APPLICATION NO.	FILING DATE	FIRST NAMED INVENTOR	ATTORNEY DOCKET NO.	CONFIRMATION NO.
09/681,403	03/29/2001	Tore Fosse	VCC0082-US	3278

Office Action Summary

Claims 21, 22, and 27 – 42 are rejected under 35 U.S.C. 103(a) as being unpatentable over Young (US 5,480,184). Young discloses a hub (see Fig. 2) for fixing to a steering column (S in Fig. 2), a substantially conical bowl-shaped element (see Fig. 2) connected to the hub with at least one spoke (see Figs. 1, 2), the spoke further connecting the bowl-shaped element to a steering wheel rim (B in Fig. 1, 2), wherein the hub, bowl-shaped element, and at least one spoke are integrally formed as a single material item (see Fig. 2), the bowl-shaped element further comprising an upper shell part (24 in Fig. 2) and lower shell part (see area near 19 in Fig. 2), the upper shell part having larger outer dimensions than the lower shell part and the upper and lower shell parts are connected by a ledge extending substantially in the radial direction relative to the

FIG. 2

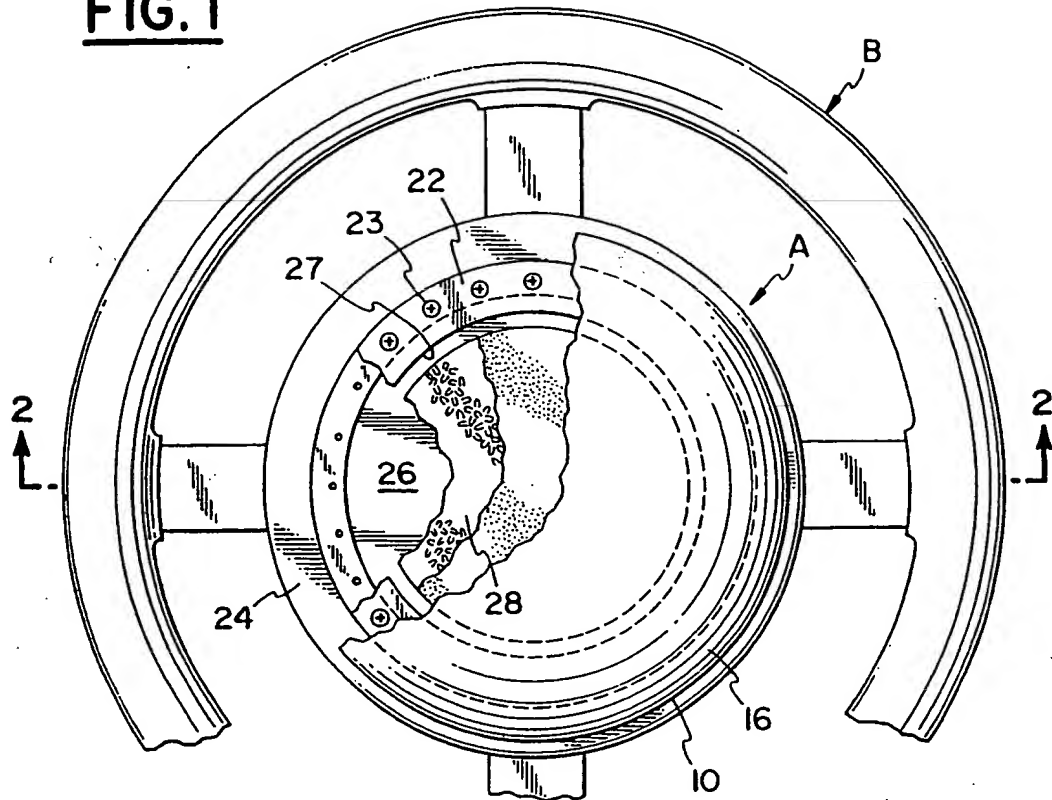
longitudinal axis of the steering column (see Fig. 2), the bowl-shaped element also comprising a casing for enclosing an airbag and means for inflating the airbag substantially disposed in the lower portion of the steering wheel (18 in Fig. 2), where a wall section of the bowl-shaped element at least partly forms part of the means for inflating the airbag (see area, attachment at 19 in Fig. 2).

Regarding Applicant's argument that Young does not teach or suggest a ledge that extends substantially in the radial direction relative to the longitudinal axis of the steering column, the examiner disagrees. Young shows a ledge, which extends substantially in a radial direction relative to the longitudinal axis, as shown in Figure 2 of the attachment.
